Notice of Intent

Sundry ID: 2754851

Type of Action: APD Change

Procedure Description: Mewbourne Oil Company request a variance to perform break testing and offline cementing on the following wells: Querecho 23/26 Fed Com 523H Querecho 23/26 Fed Com 616H Night Watch 2/1 Fed Com 511H Night Watch 2/1 Fed Com 513H Gemini 36/35 Fed Com 513H Gemini 36/35 Fed Com 516H Corona 25/26 Fed Com 525H Corona 25/26 Fed Com 528H Pavo Macho 31/33 Fed Com 616H Pavo Macho 31/33 Fed Com 618H

Figure 3. BOP handling system

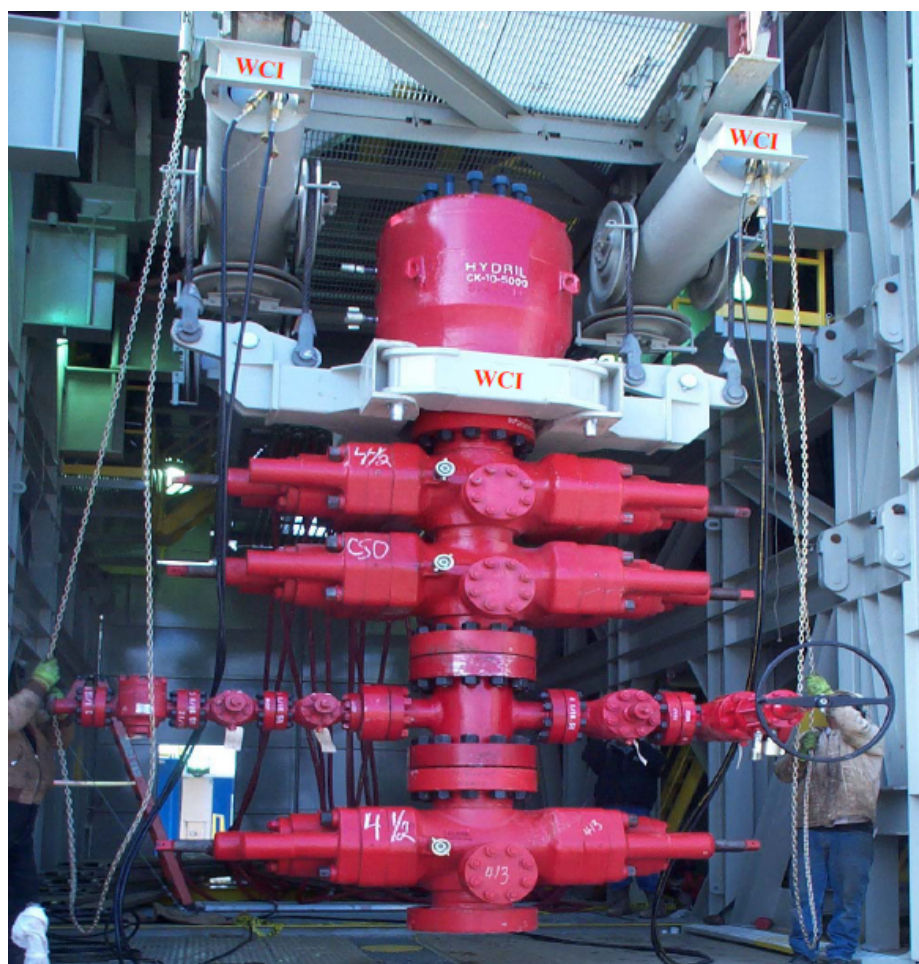
4. The BOP will be removed and carried by a hydraulic carrier (Fig. 3 & 4).
5. The rig will then walk to the next well.
6. Confirm that the well is static and remove the capping flange.

- While in transfer between wells, the BOPE shall be secured by the hydraulic carrier or cradle.
- Any well control event while drilling require notification to the BLM Petroleum Engineer (575-706-2779) prior to the commencement of any BOPE Break Testing operations.

Figure 5. Cactus 5M wellhead with BOP quick connect

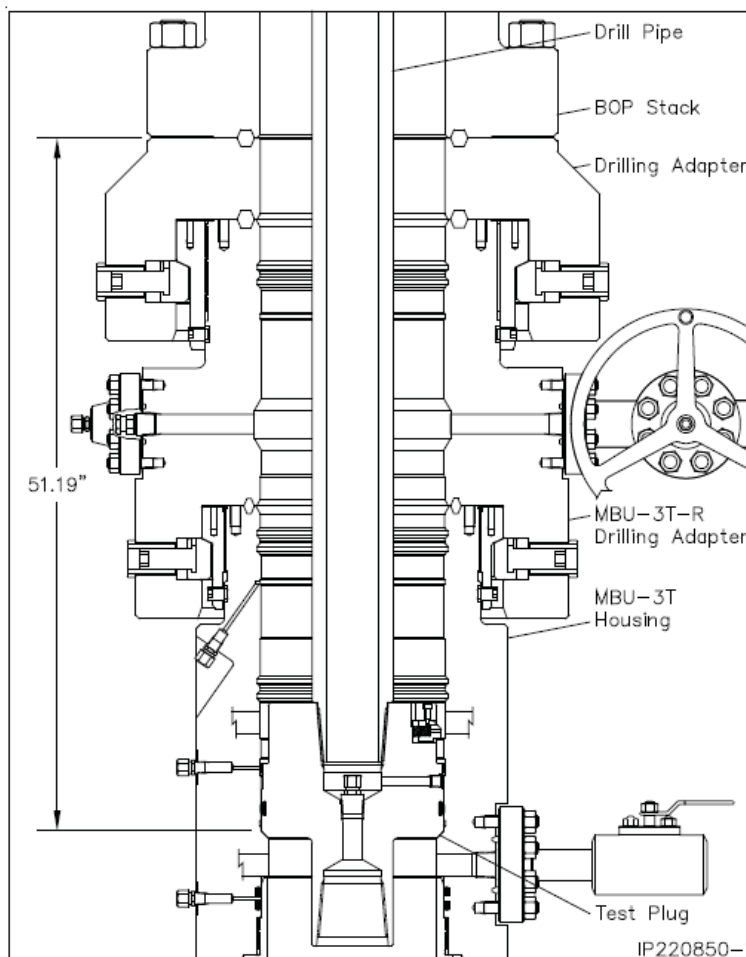
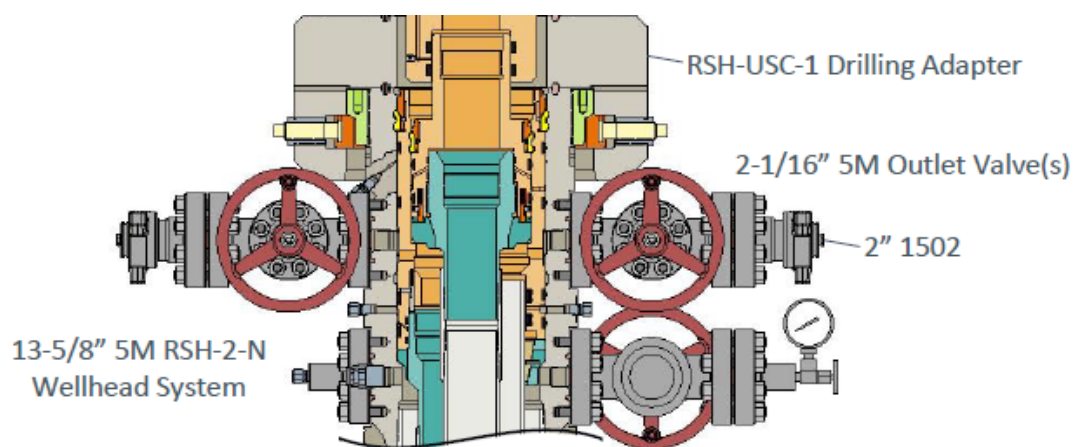
- Connection between the flex line and the HCR valve
 - Connection between the wellhead and the BOP quick connect (Fig. 5 & 6).
3. A capping flange will be installed after cementing per wellhead vendor procedure & casing pressure will be monitored via wellhead valve.
